Technical Bulletin

Bulletin No: TCH-008-030-A Effective Date: 4/12/99 Cancels: N/A Page: 1 of 3

Subject: UPGRADED AD-9 MAINTENANCE KIT

Kit 5005037

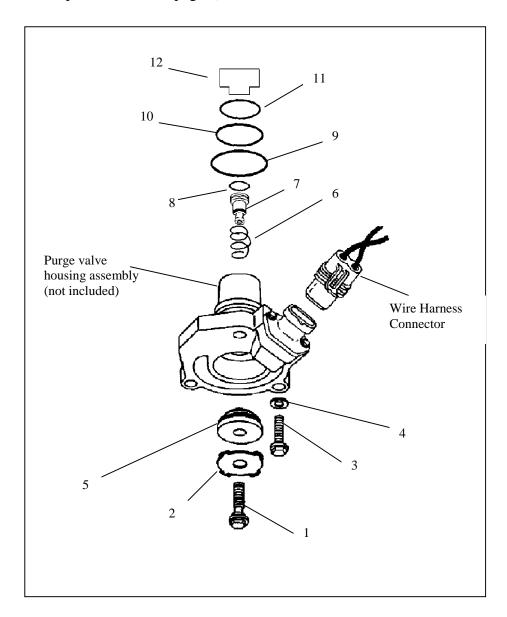
This is to announce the availability of a new, upgraded maintenance kit for the AD-9 air dryer. The new kit, 5005037, replaces the obsolete 5004336 kit.

The change in the kit brings the purge valve up to new design standards. An optimized seal design increases the air dryer's resistance to freeze-ups and reduces mechanical sticking of the purge piston. The kit's assembly tool is required for inserting the new purge piston.

- Kit 5005037 is the hard seat piston
- Kit 5005893 is the soft seat piston
